TRUCK UTILITY MEDIUM (TUM) HS

MODIFICATION INSTRUCTION No. 13

SUBJECT: Fitting Glow plug timer interface harness

SUBJECT: Fire extinguisher

Fig 1 Fitting the Glow plug timer interface cable – Basic Wolf

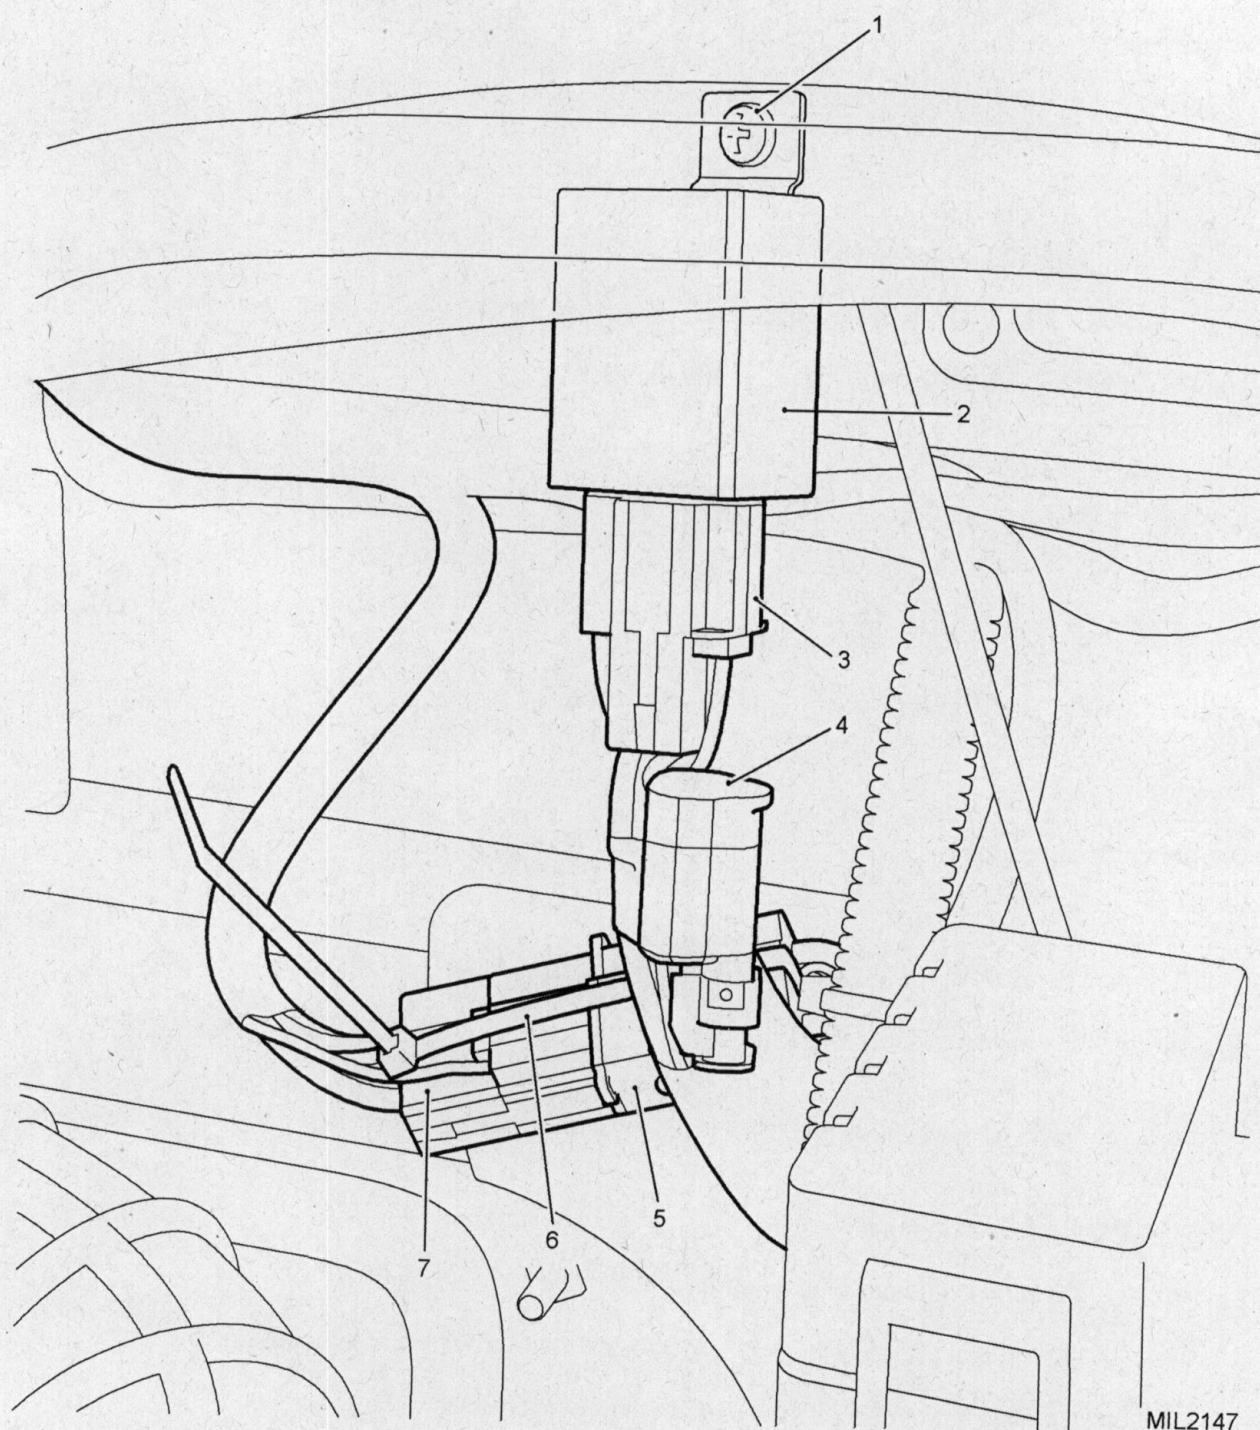
10 Basic Wolf Vehicles (refer to Fig 1):

- 10.1 Disconnect the negative lead from the battery.
- 10.2 Disconnect the Glow plug timer located on the engine side of the bulkhead.
- 10.3 Remove screw securing the existing glow plug timer from the bulkhead.
- 10.4 Replace with the new glow plug timer and interface harness.
- 10.5 Connect the main harness socket to the interface harness plug.
- 10.6 Using the cable tie (item 3) secure the plug and socket together.
- 10.7 If required, any excess main or interface harness should be looped and cable tied up to the dash wiring use a cable tie (item 4).
- 10.8 Reconnect the negative lead to the battery.

Fig 2 Fitting the Glow plug timer interface cable – Winter Water

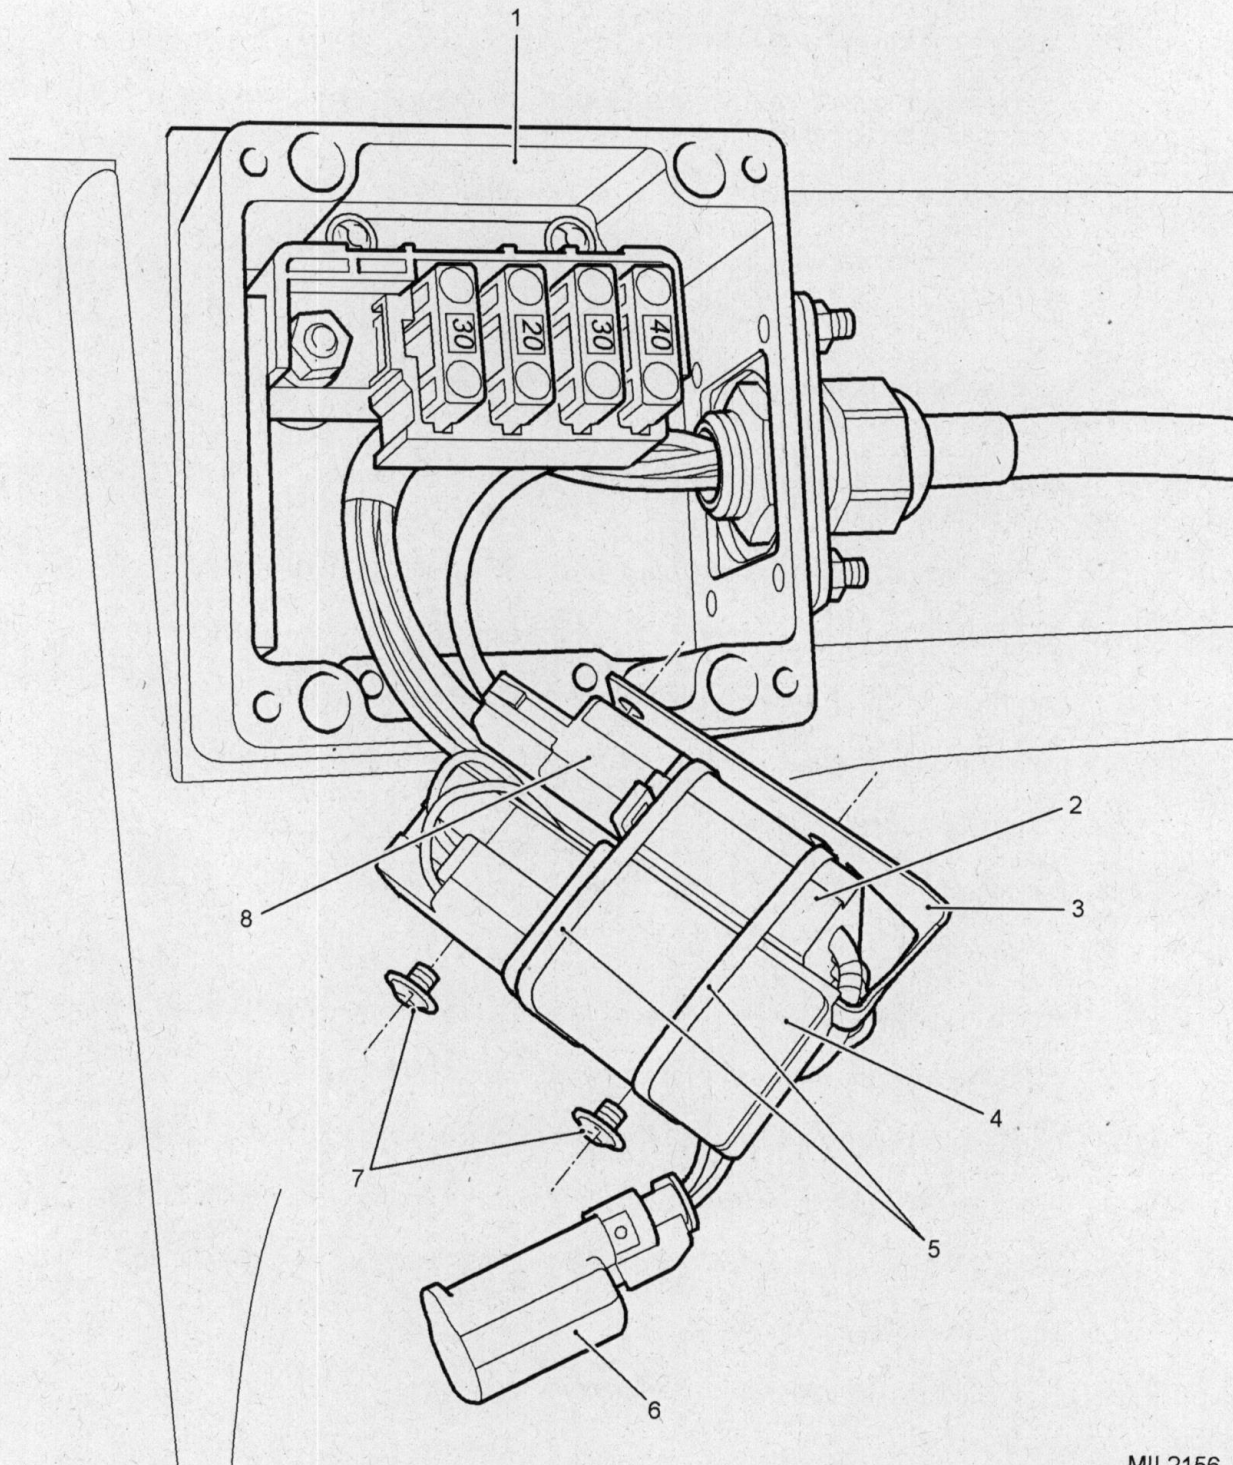
11 Winter Water Vehicles (refer to Fig 2 and 3):

- 11.1 Disconnect the negative lead from the battery.
- 11.2 Undo the four screws and remove the fuse box cover from the Main harness fuse box located on cab side of the lower dash.
- 11.3 Remove the mounting bracket from the new Glow plug timer.
- 11.4 Remove the tape securing the Spark Suppressor to the interface harness.

- 11.5 Remove the two screws securing the glow plug timer mounting bracket to the inside of the fuse box.
- 11.6 Attach the Glow plug timer and Interface harness onto the mounting bracket, secure with two cable ties (item 4) (refer to fig 2).
- 11.7 Carefully shape the harness by hand to enable fitment into the fuse box.
- 11.8 Connect the Glow plug timer Interface harness plug to the main harness socket.
- 11.9 Secure the mounting bracket to the fuse box with the existing screws.
- 11.10 Install the Spark suppressor and connecting wires into the fuse box (refer to Fig 3).
- 11.11 Fit the fuse cover and gasket.
- 11.12 Reconnect the negative lead to the battery.

Fig 3 Fitting the Glow plug timer interface cable – Winter Water

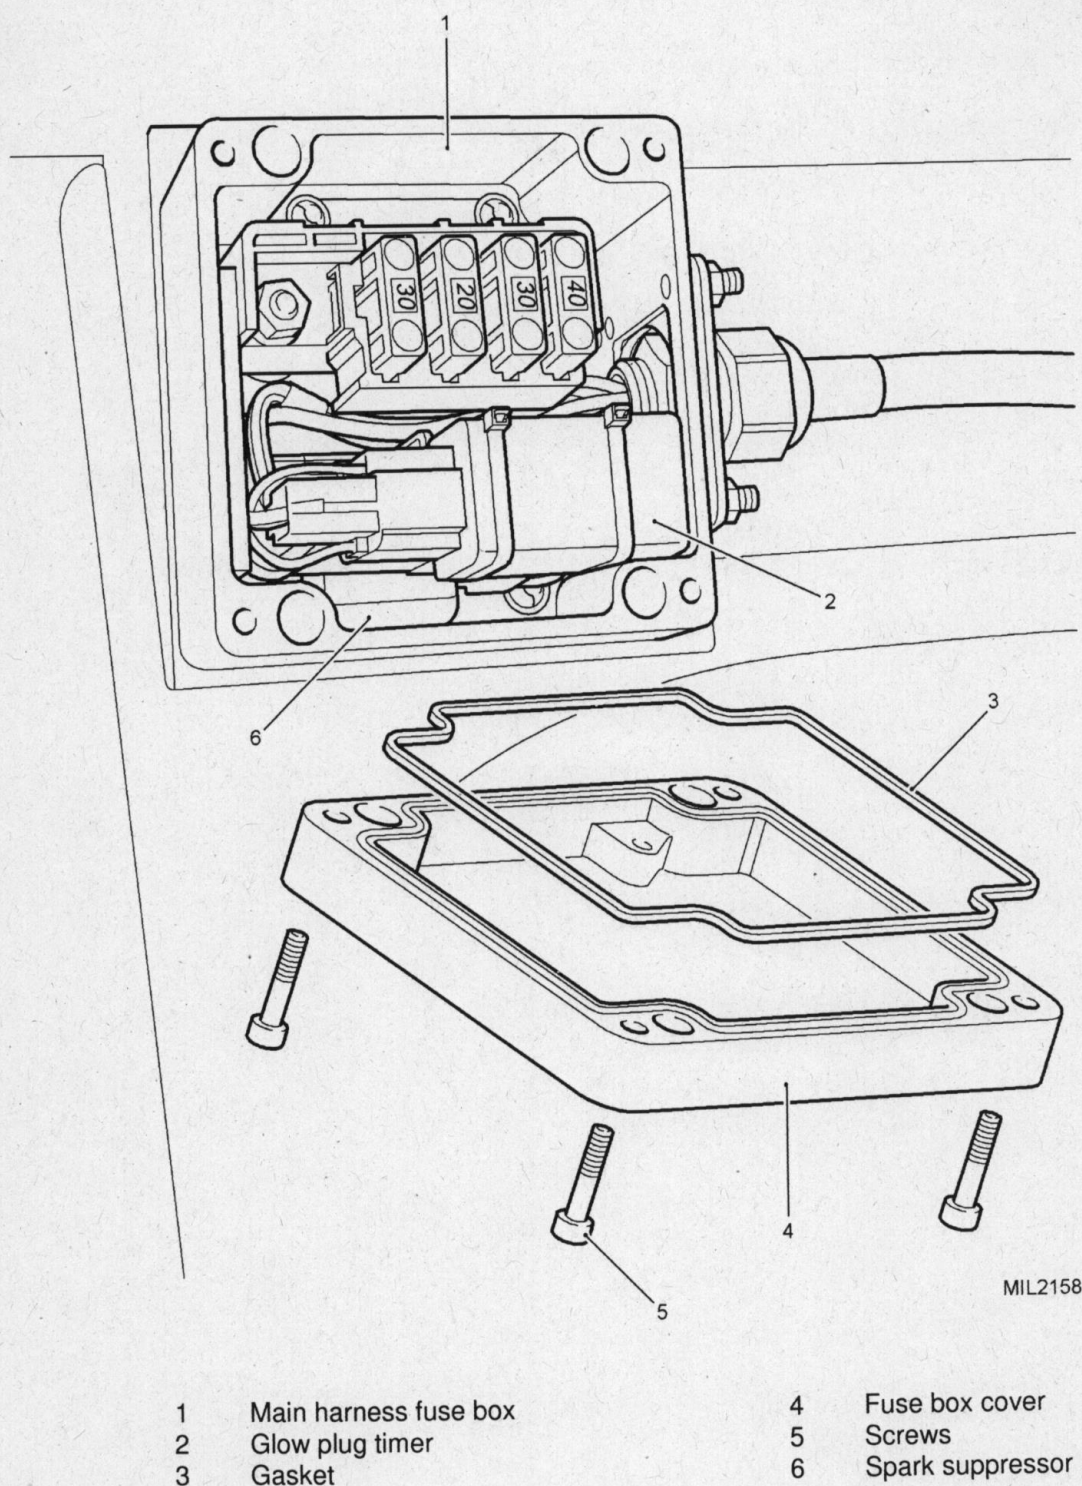
- 11.13 Attach the Glow plug timer to the Interface harness, secure with two cable ties (item 4).
- 11.14 Carefully shape the harness by hand to enable fitment into the fuse box.
- 11.15 Connect the Glow plug timer Interface harness plug to the main harness socket.
- 11.16 Install the Glow plug timer Interface harness to the mounting bracket in the fuse box.
- 11.17 Install the Spark suppressor and connecting wires into the fuse box (refer to Fig 3).
- 11.18 Fit the fuse cover and gasket.
- 11.19 Reconnect the negative lead to the battery.

Fig 4 Fitting the Glow plug timer interface cable – Snatch 2 and Military Core Vehicles

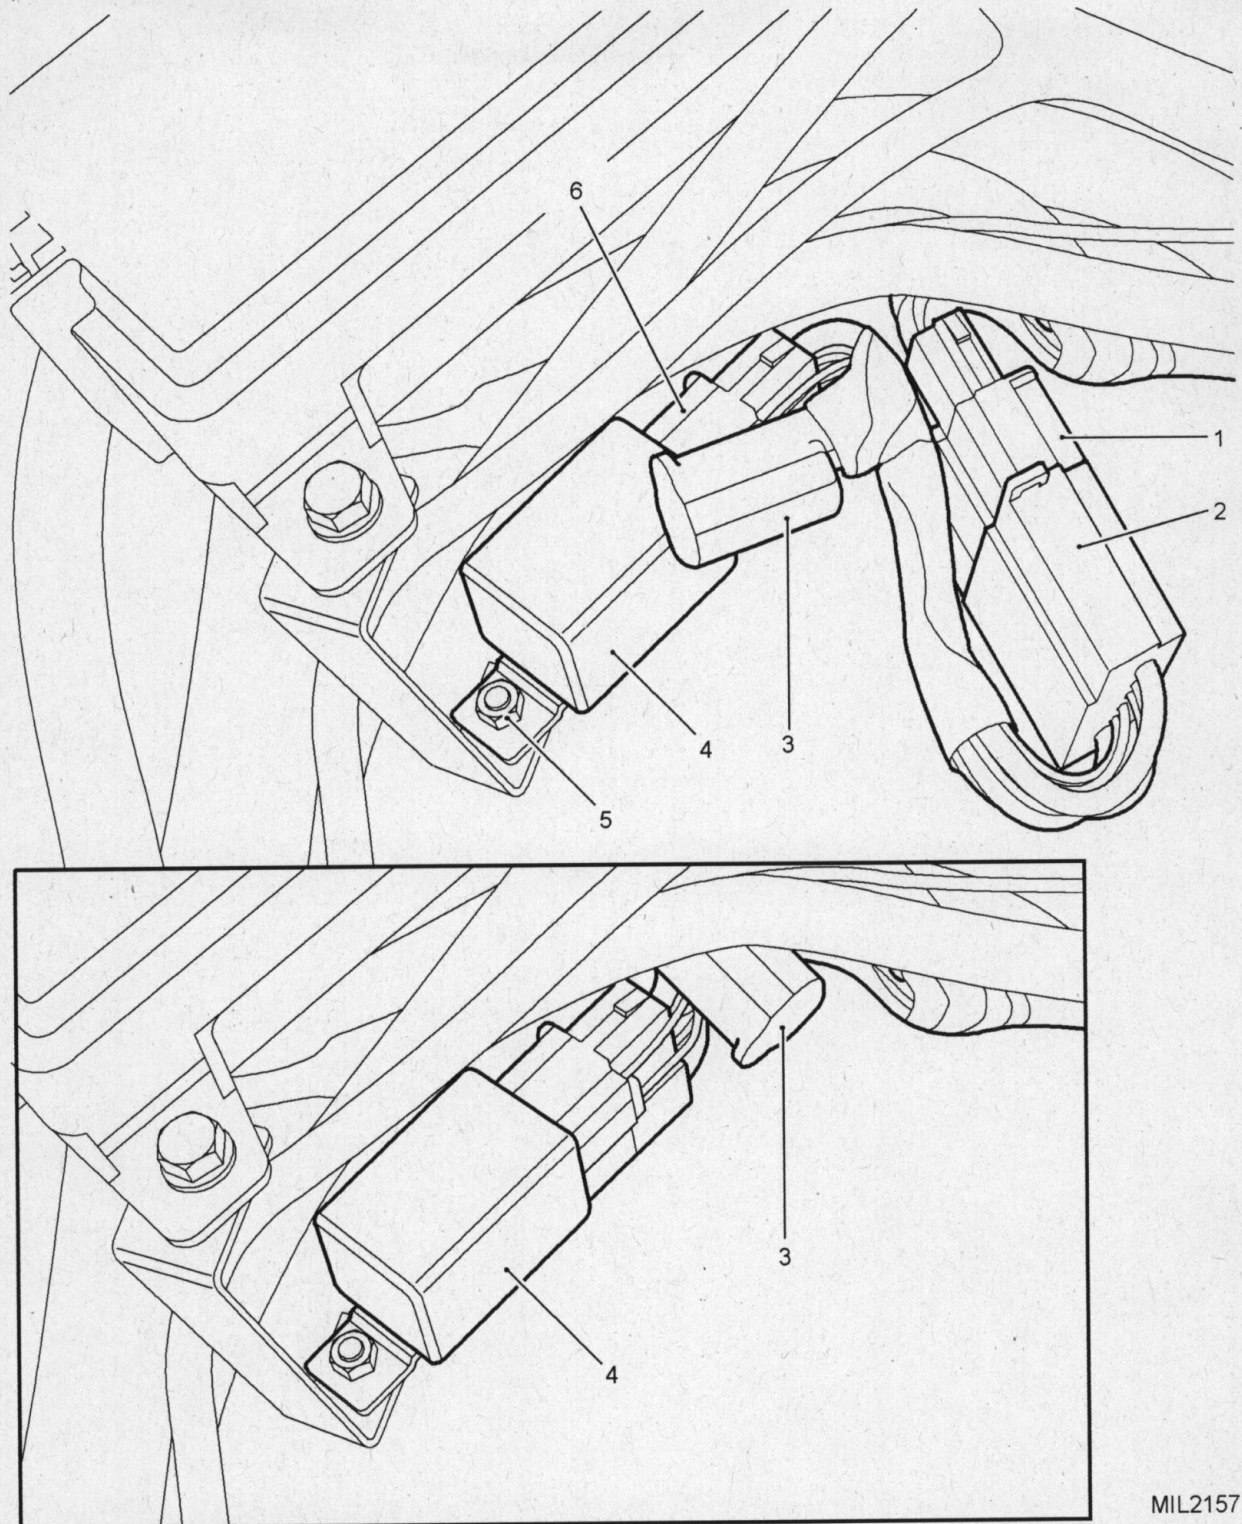
12 Snatch 2 and Military Core Vehicles (refer to Fig 4):

- 12.1 Disconnect the vehicle batteries (refer to Cat 522, Chap 13).
- 12.2 Remove the vehicle battery closest to the under seat fuse box.
- 12.3 Remove plug from existing Glow plug timer.
- 12.4 Remove nut securing existing Glow plug timer.
- 12.5 Remove Glow plug timer and bracket.
- 12.6 Install new Glow plug timer, bracket and interface harness.
- 12.7 Connect interface harness plug to the main harness socket.
- 12.8 Position Glow plug timer interface harness underneath the existing harness.
- 12.9 Refit vehicle battery.
- 12.10 Reconnect the vehicle batteries.

Fig 2 Removal of existing fire extinguisher and bracket

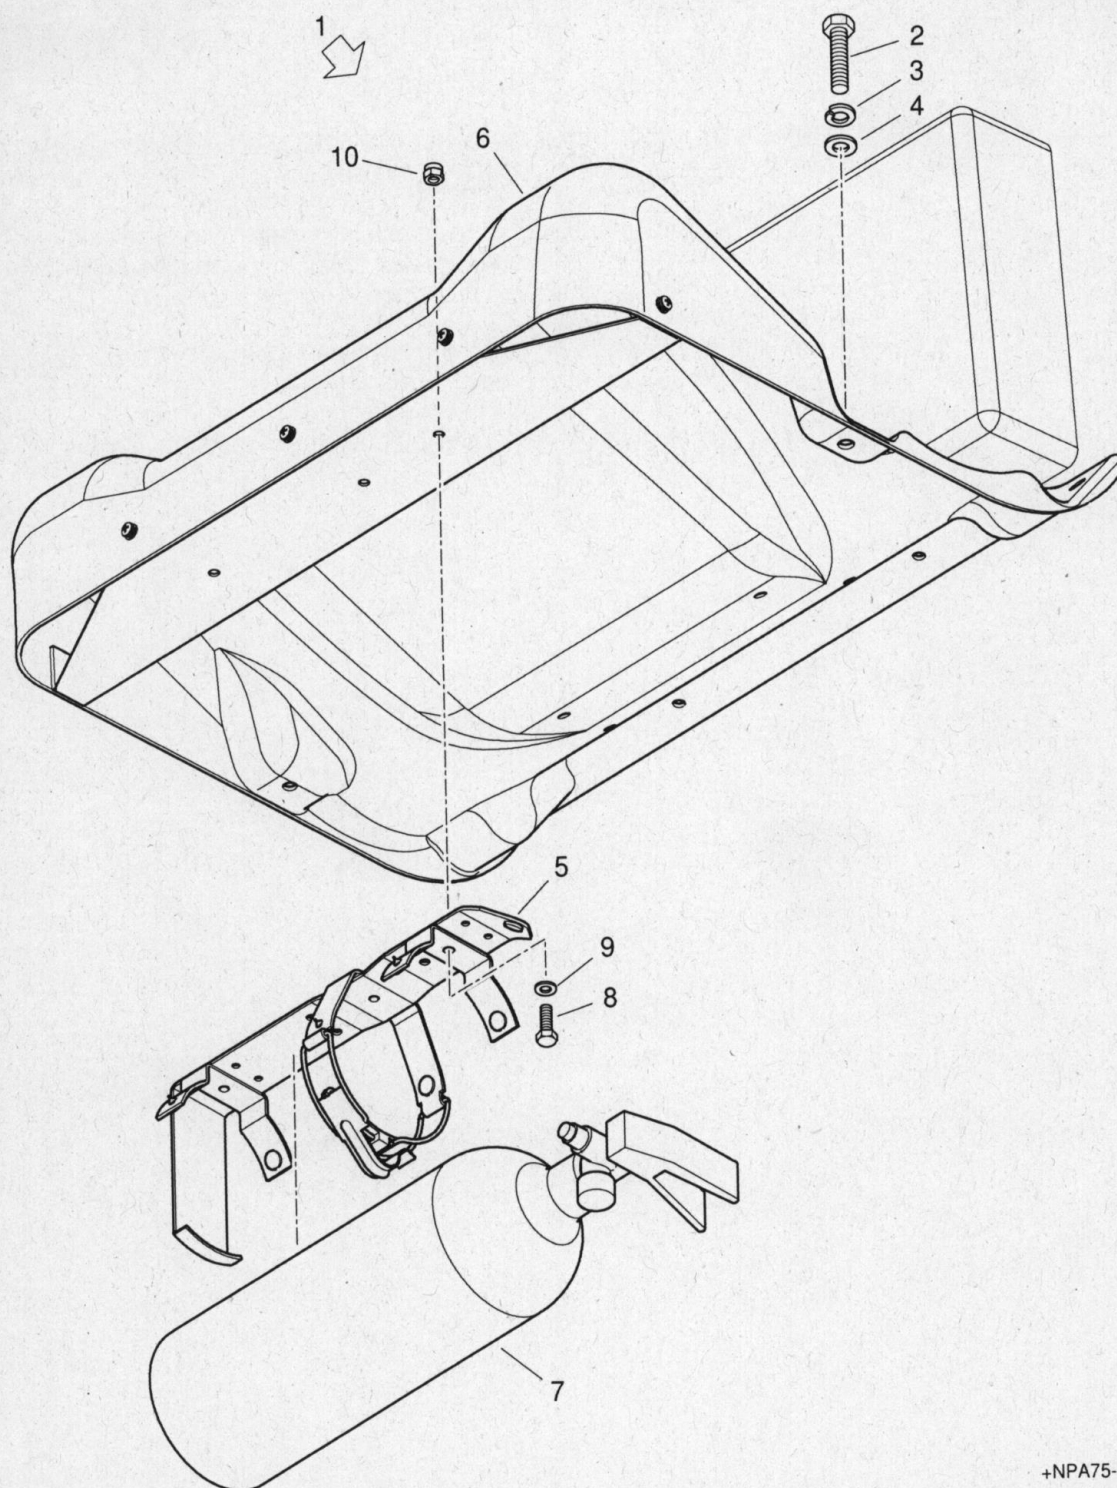
12 The fire extinguisher and bracket under the forward RH rear seat (Fig 2(1)) must be disconnected and removed. In order to facilitate the removal of the fire extinguisher bracket (5), the seat (6) must also be removed as follows:

12.2 Remove the seat belt retaining bolts and the seatbelt. Retain the seat belt and fixings for refitting. Remove the rear most seat securing bolts and retain.

12.3 Remove the securing bolts (2) spring washers (3) and plain washers (4) and remove the seat. Retain the seat and fixings for refitting.

12.4 Remove the fire extinguisher (7) from the fire extinguisher bracket (5) and retain.

12.5 Remove and discard the screws (8) washers (9) and nyloc nuts (10) securing the fire extinguisher bracket to the seat. Retain the fire extinguisher bracket for refitting in the front compartment.

Fig 3 Fire extinguisher bracket to extinguisher bracket (mounting)

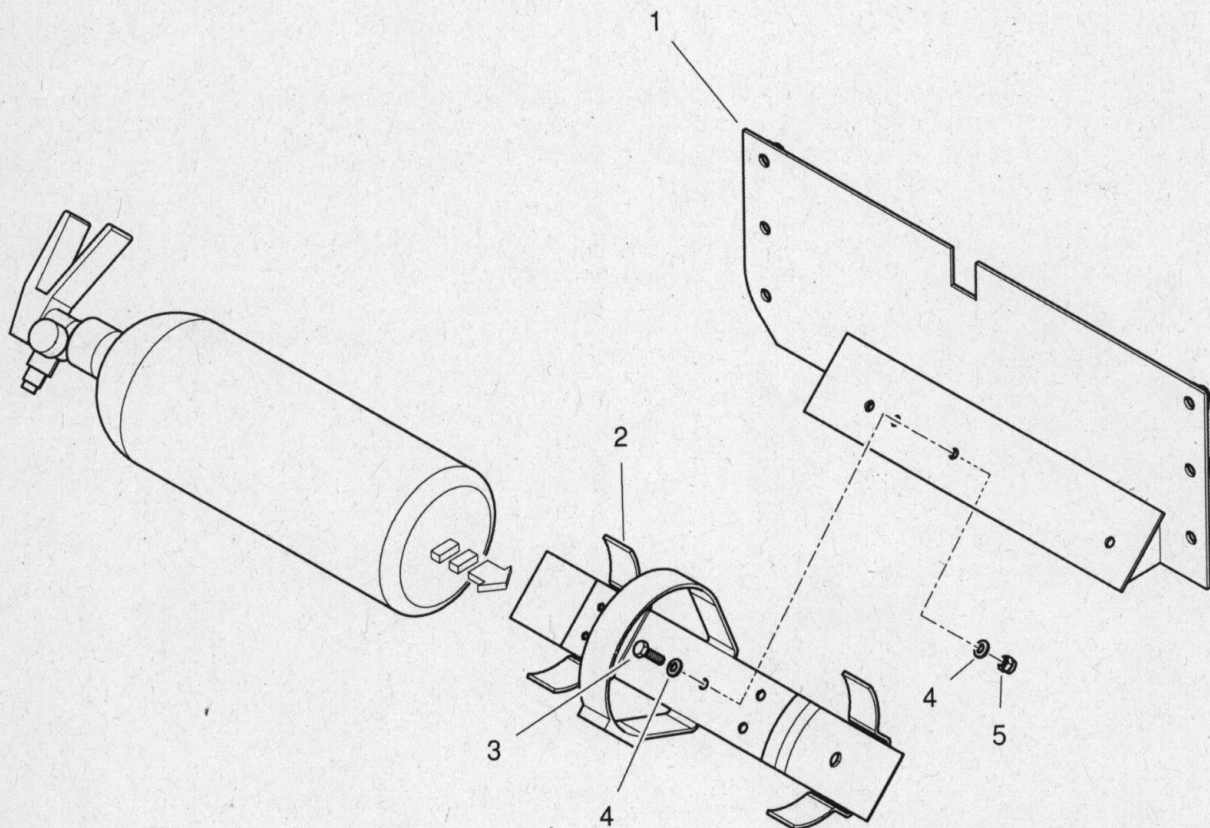
14 To fix the retained fire extinguisher bracket (Fig 3(2)) and supplied fixings to the extinguisher bracket (mounting)(1) proceed as follows:

14.1 Using the extinguisher bracket (mounting) as a template, ensure correct alignment of the four holes required before drilling the fire extinguisher bracket holes to the required diameter. The fire extinguisher bracket may be pre-drilled; therefore this stage is not necessary.

14.2 Using a suitable drill and 6.5 mm drill bit, drill the four holes in the fire extinguisher bracket. Once drilled, remove any burrs from around the holes.

14.3 Fit the fire extinguisher bracket to the extinguisher bracket (mounting) using screws (3), washers (4) and nuts (5).
